Technical Memorandum 10.2

Assessment of Groundwater- Surface Water Interactions

**for the Regional Groundwater
Storage and Recovery Project
and San Francisco Groundwater
Supply Project**

Supplemental Explanation for Hydrographs - TM10.2

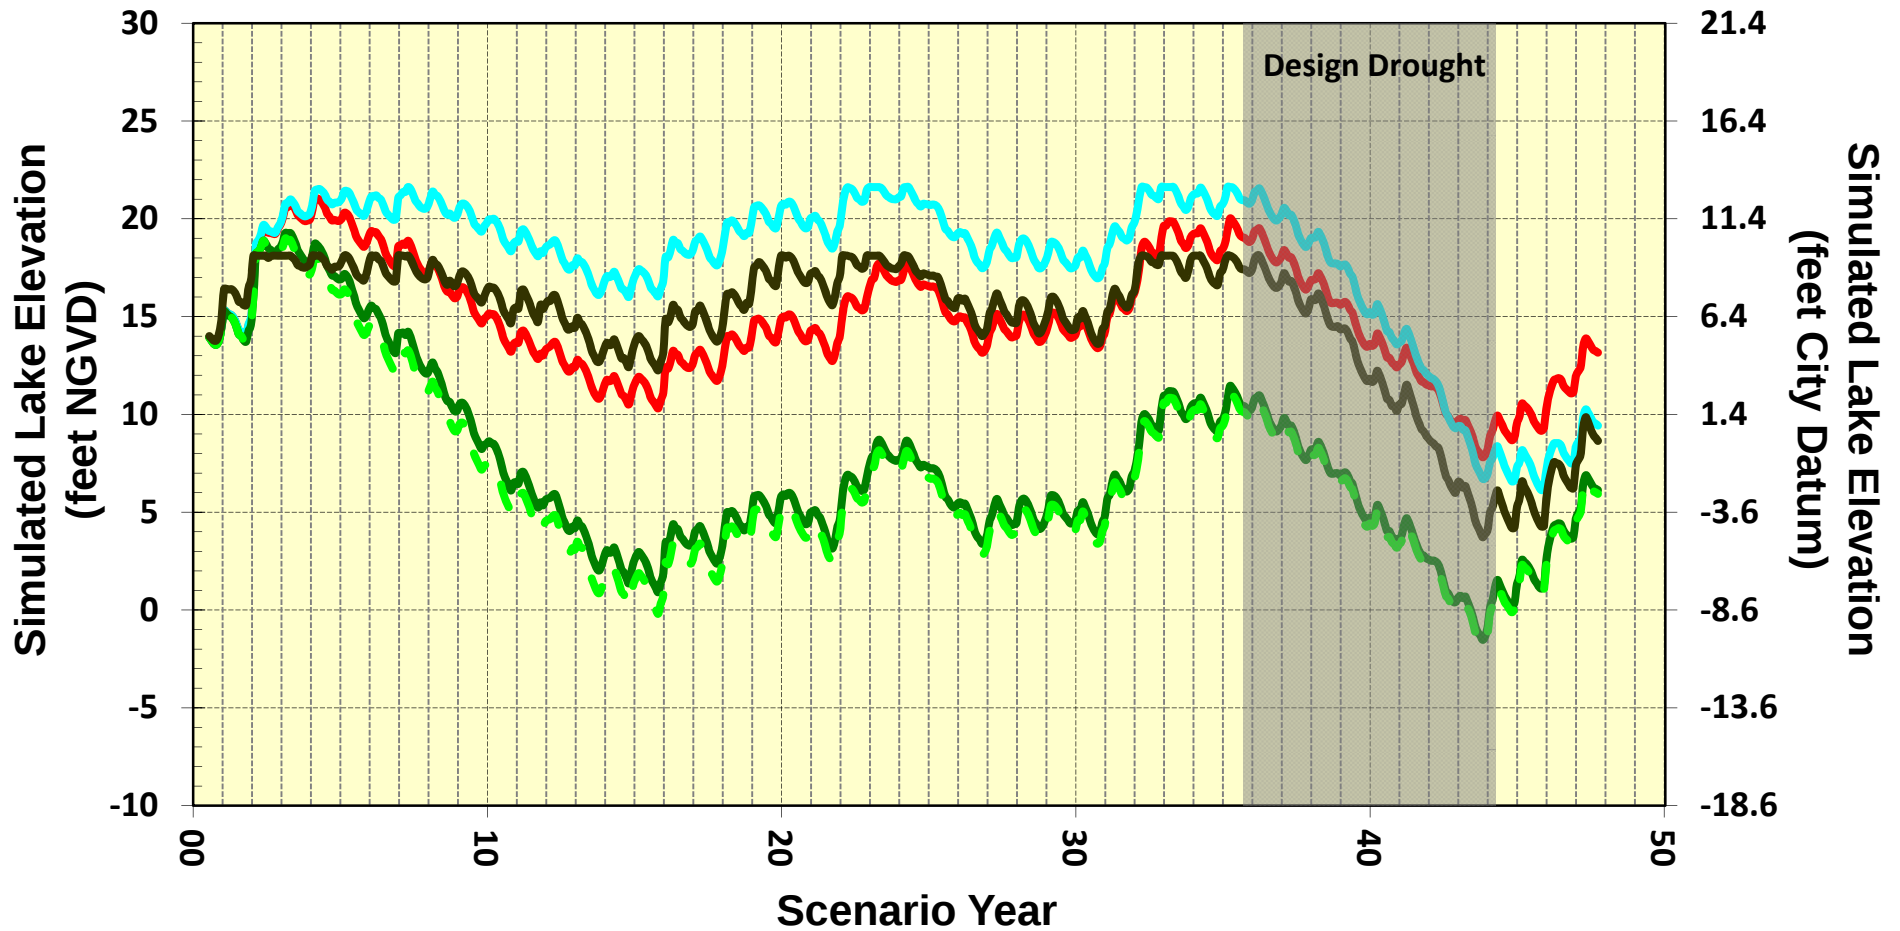
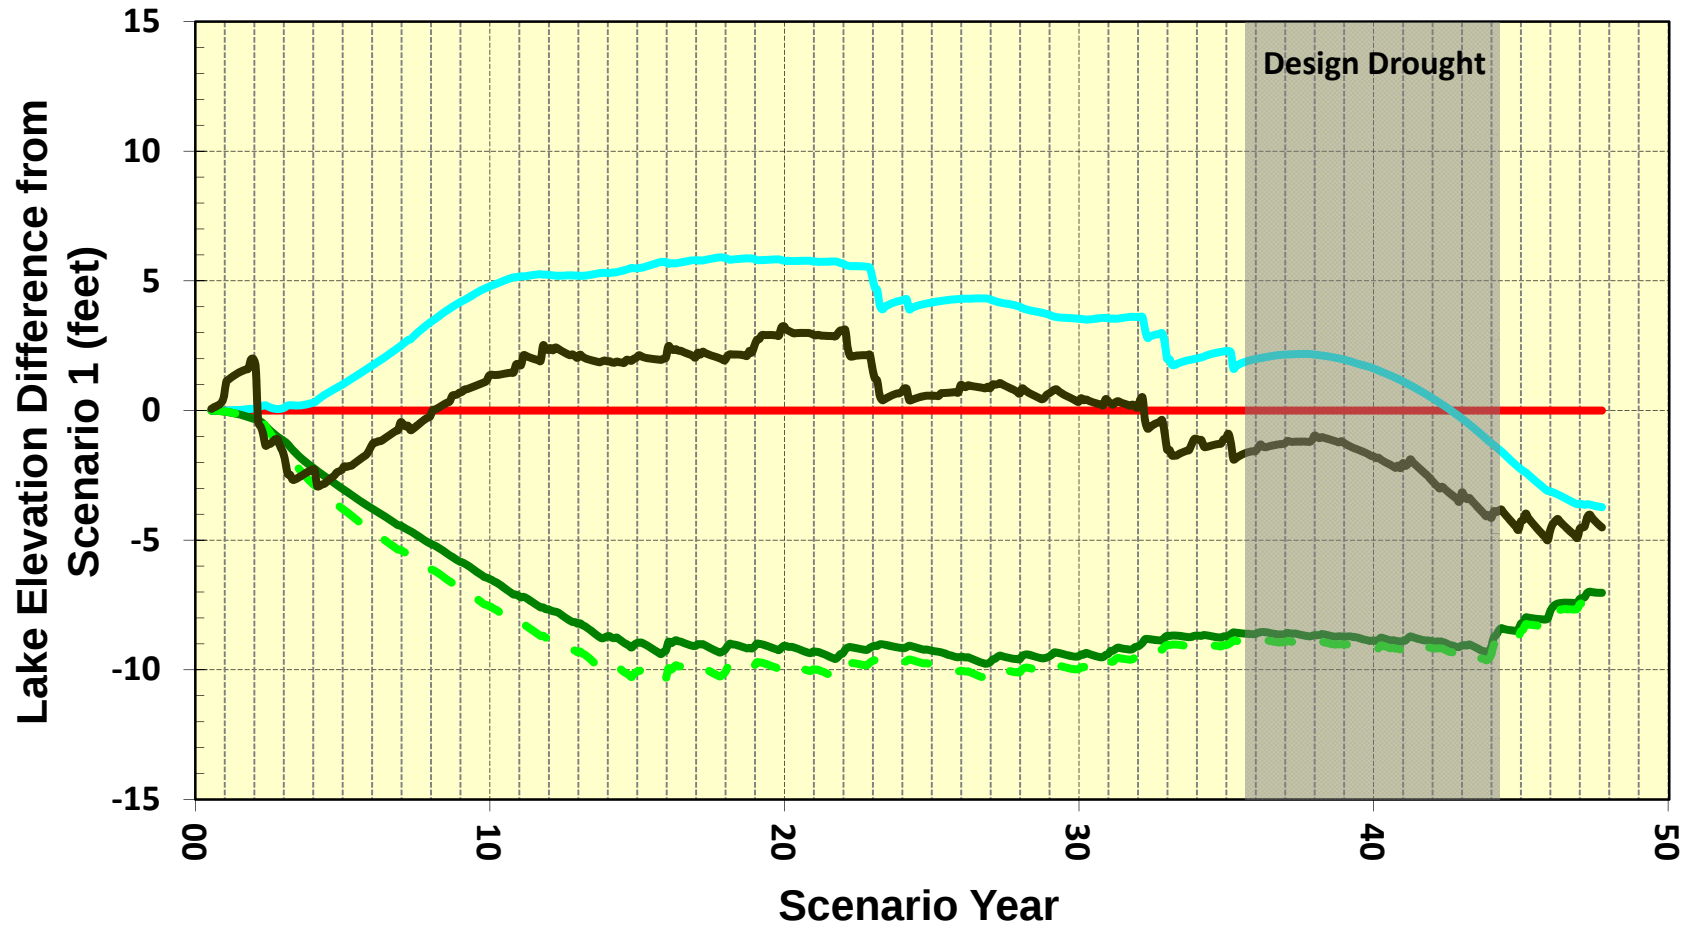
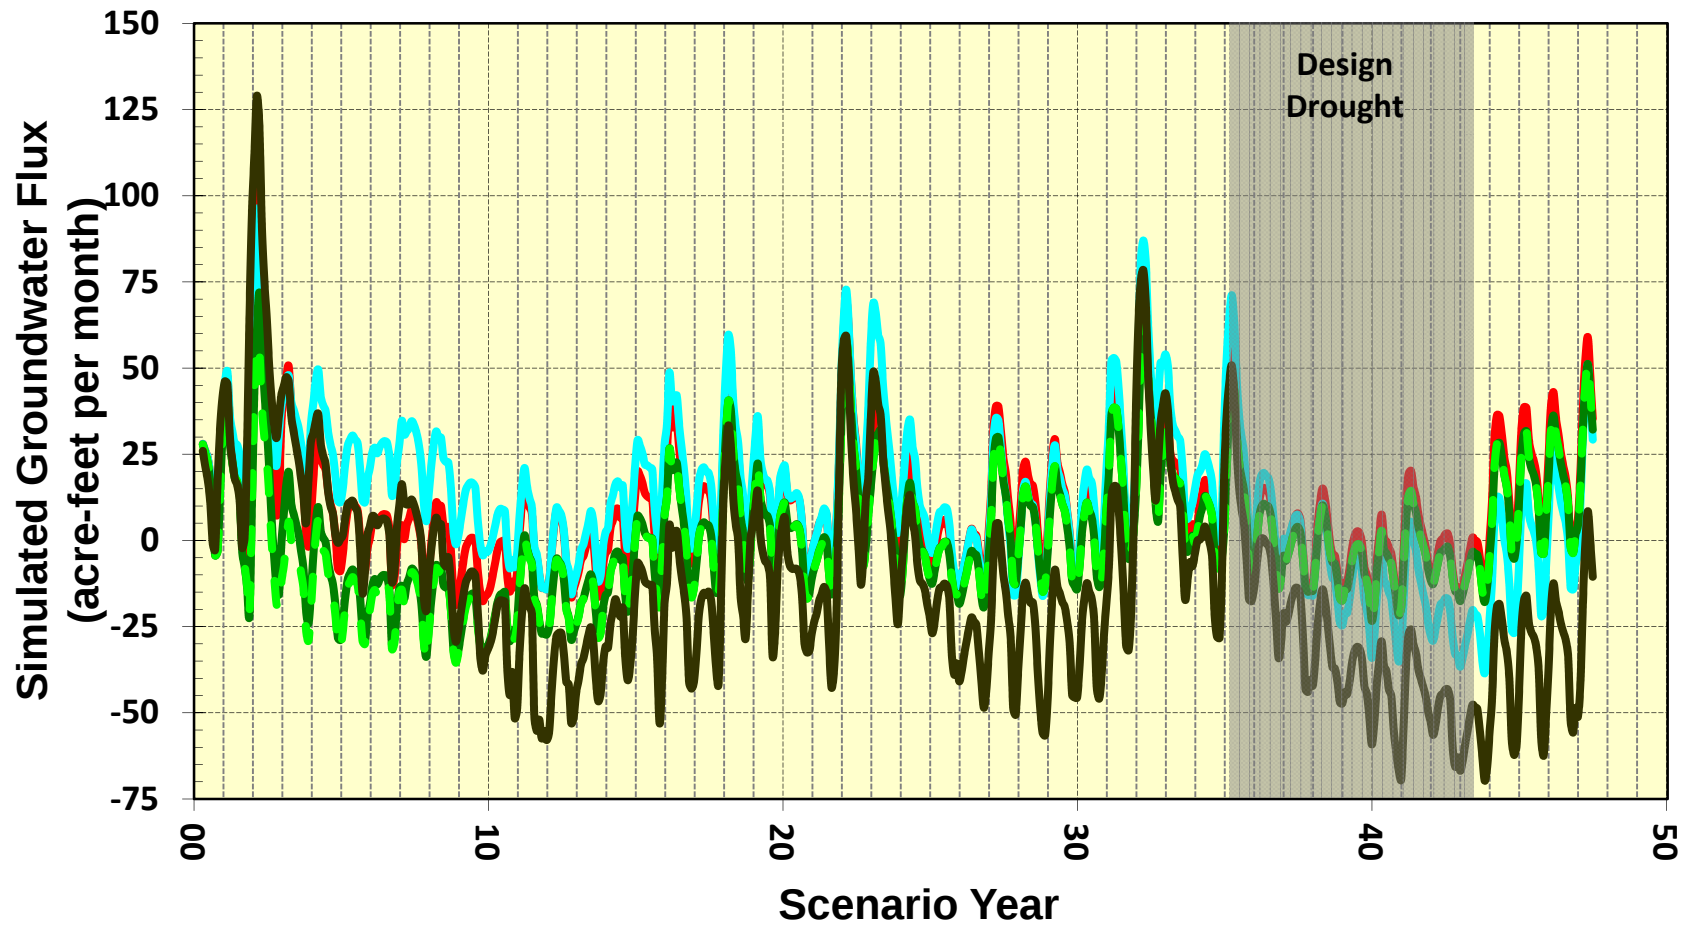
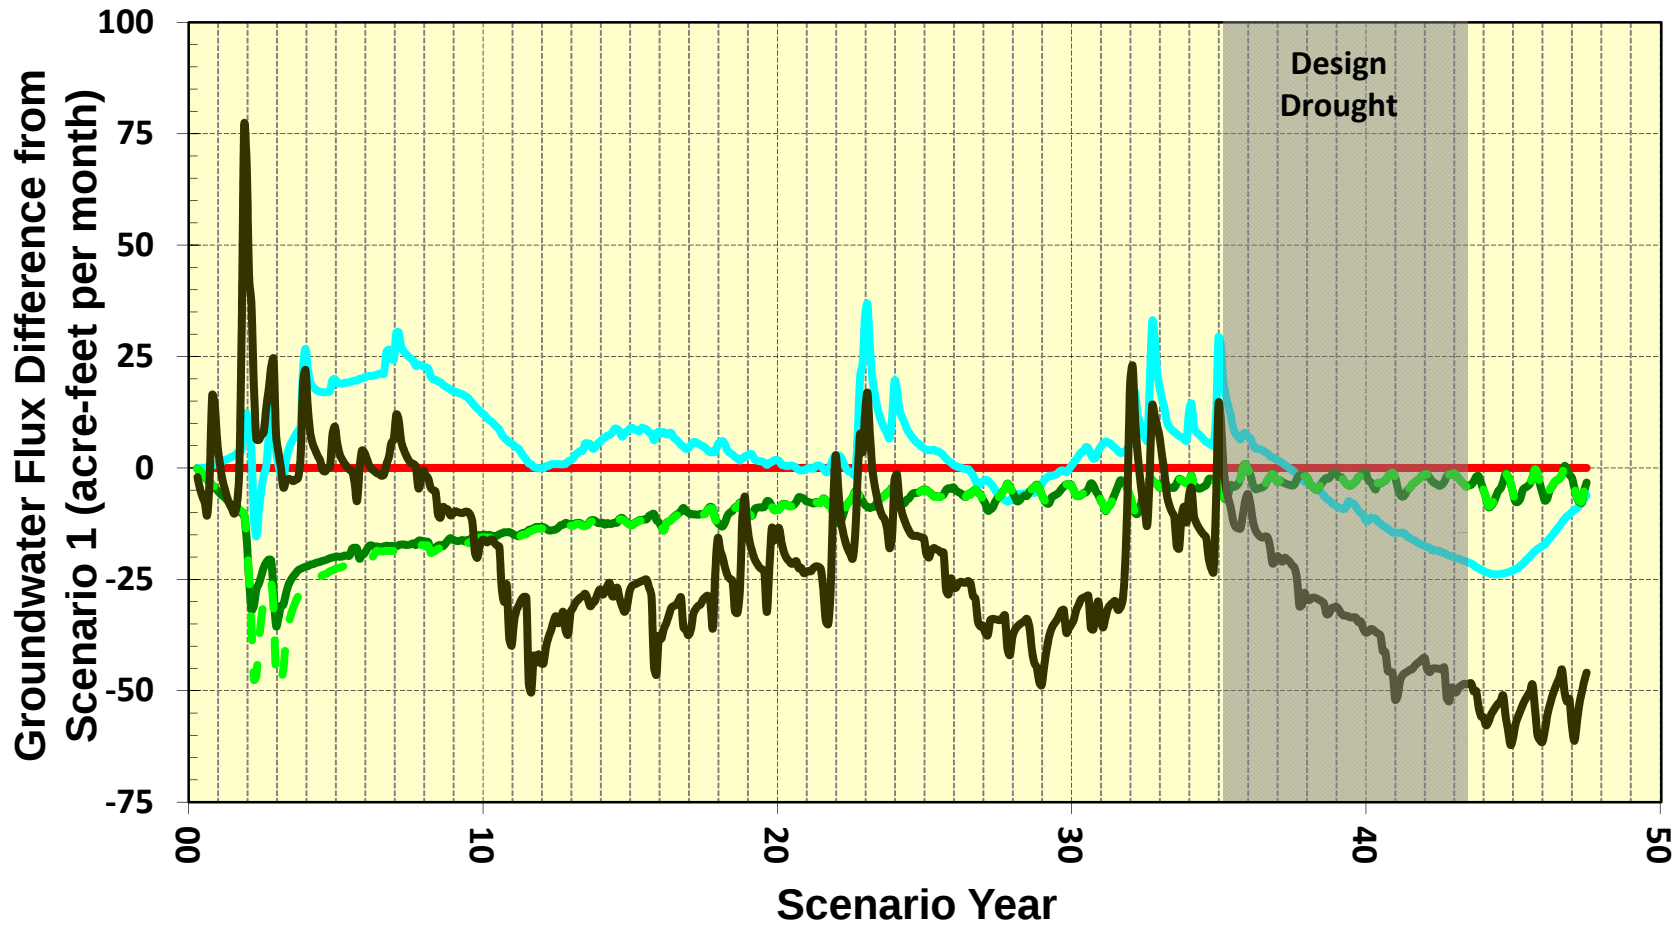
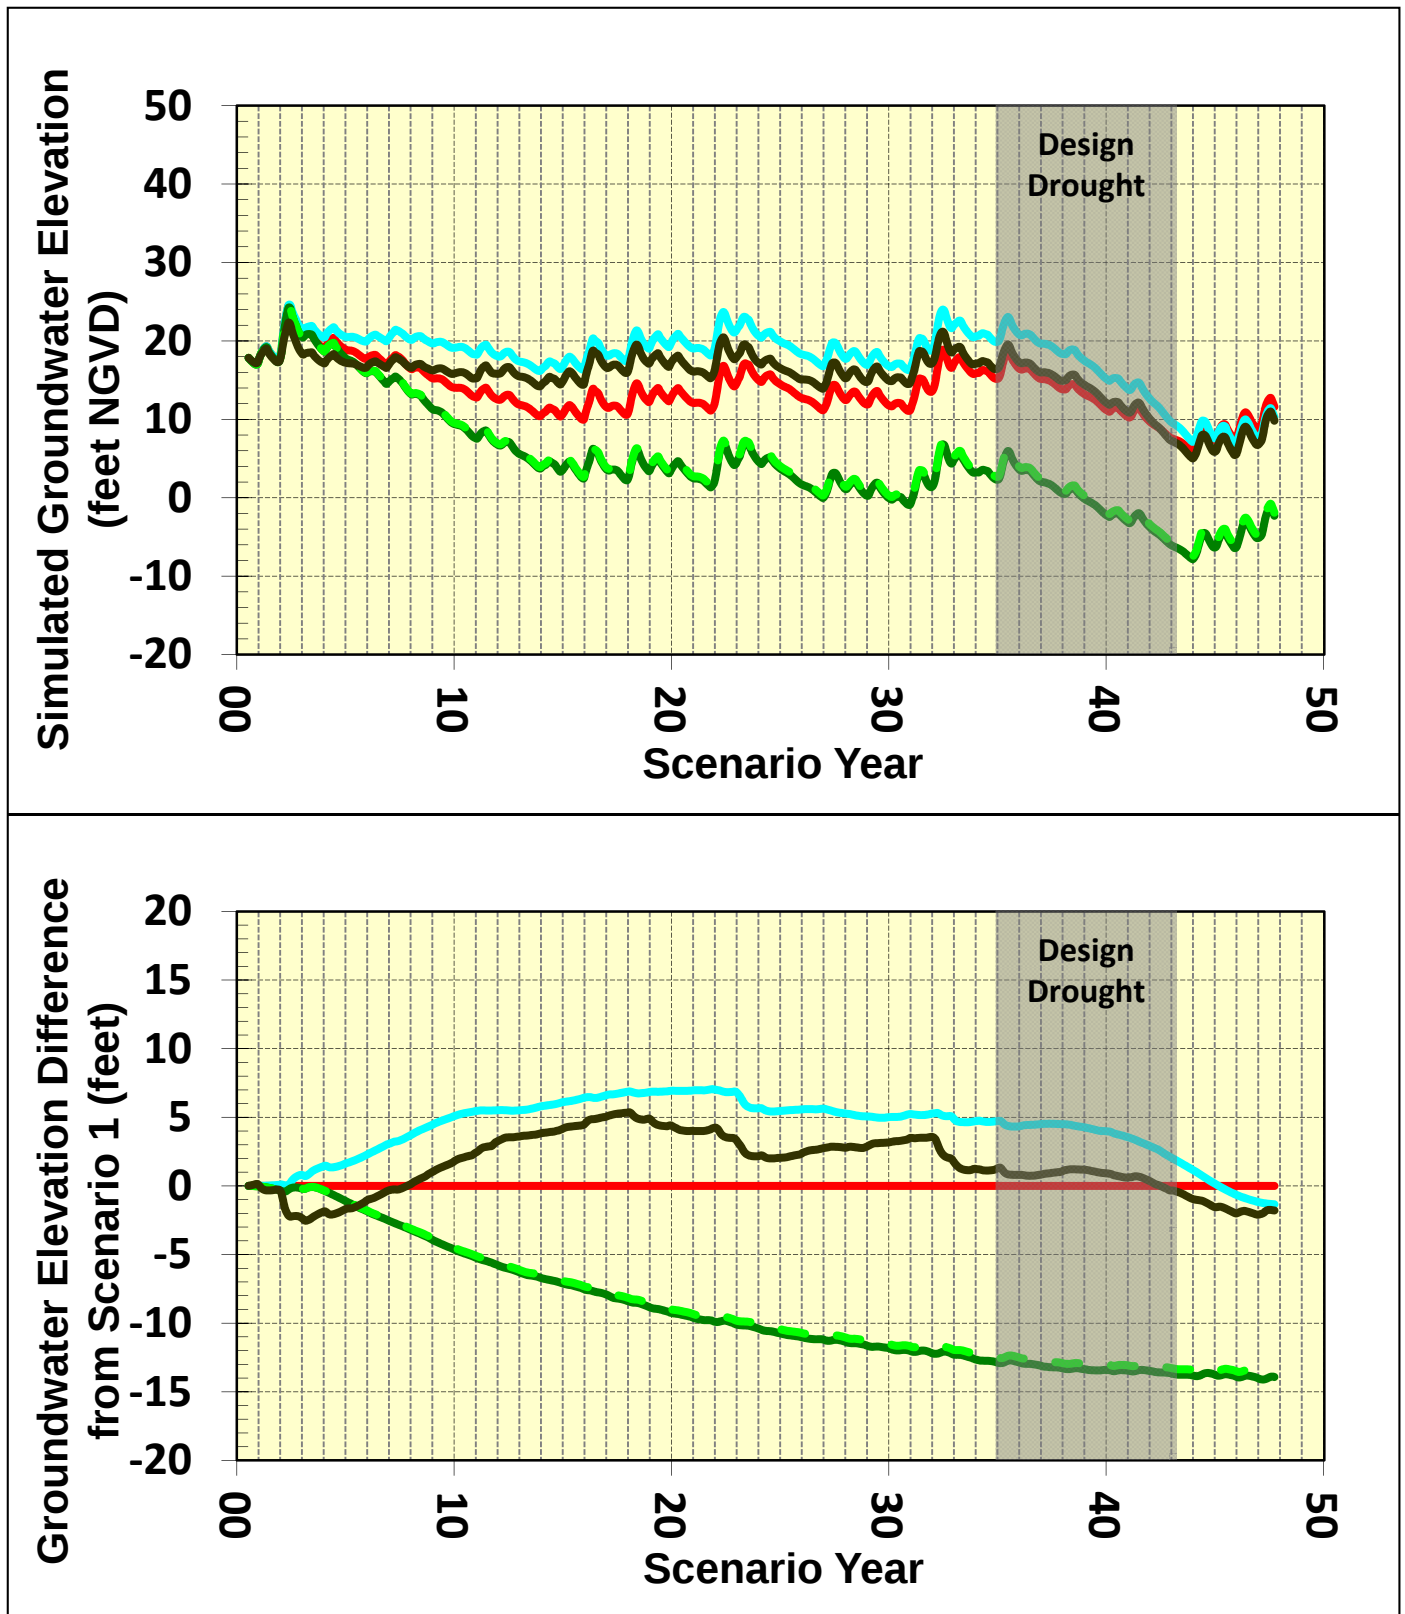
First, the x-axis on several graphs showing model results was shifted. The x-axis is named Scenario Year which should correspond to a water year¹. However, the graph template was plotted using a calendar year, so the intervals on the x-axis represent the period from January to December. The result is that the graph is shifted 3-months later relative to Scenario Year.

Second, the shaded area representing the Design Drought was added manually and because of this process, it was not presented consistently on the graphs. By definition per the PEIR, the 8.5-year Design Drought includes one Hold year before the 7.5-year Take period. In addition, the Design Drought needs to be shifted 3-months later for the x-axis issue to be consistent with the model output. The Design Drought should be shown as Scenario Years 35.5 to 44.0 on the shifted x-axis.

The following is a list of figures in TM 10.2 where the Design Drought shaded area is shown slightly different and does not match the correct display of the Design Drought. The figures should be viewed based on the correct representation of the Design Drought as explained above.

- o Figures 10.2-8 through 10.2-15 (a total of 13 figures) have the shifted x-axis. The Design Drought should be shown as Scenario Years 35.5 to 44.0 on the shifted x-axis.
